PUMP/MOTOR/TANK ASSEMBLY AP8086/AP8595 FENNER STONE - OBSOLETE

**MR30.4600
14APR14**

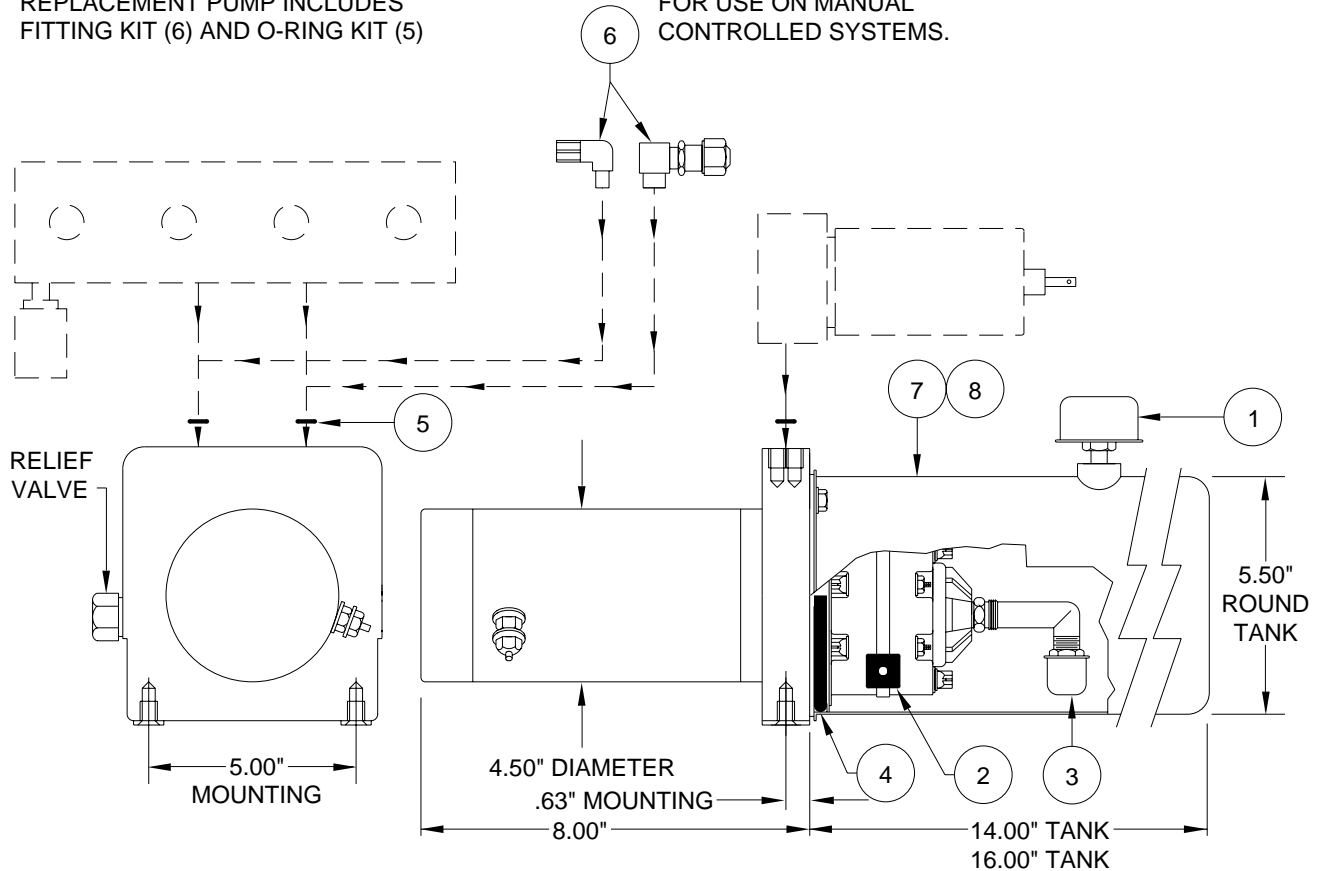
* CONTACT HWH WHEN REPLACING ONE OF THESE POWER UNITS ON A 610 PUMP/MANIFOLD. IN MIDYEAR 1992 THE PRESSURE AND RETURN PORTS ON TOP OF THE PUMPS WERE CHANGED FROM 0.438" DIA. HOLES TO 1/4" NPT (.54" DIA.) THREADED HOLES. THUS THE O-RING SPOT FACES ON THE BOTTOM OF THE MANIFOLD WERE CHANGED FROM 5/8" DIA. TO 11/16" DIA. TO ALLOW LARGER O-RINGS TO COVER THE LARGER PUMP PORT. REPLACEMENT PUMPS HAVE THE 1/4" NPT PORTS THUS THE MANIFOLD MUST BE CHECKED TO DETERMINE IF IT HAS THE 11/16" DIA. SPOT FACES. IF THE MANIFOLD DOES NOT HAVE THE 11/16" DIA. SPOT FACES IT MUST BE RETURNED TO HWH FOR RE-SPOT FACING.

** RAP9171 O-RING KIT CONTAINS (2) O2-014-9N O-RINGS FOR THE 5/8" SPOT FACE AND (2) O2-015-9N O-RINGS FOR THE 11/16" SPOT FACE.
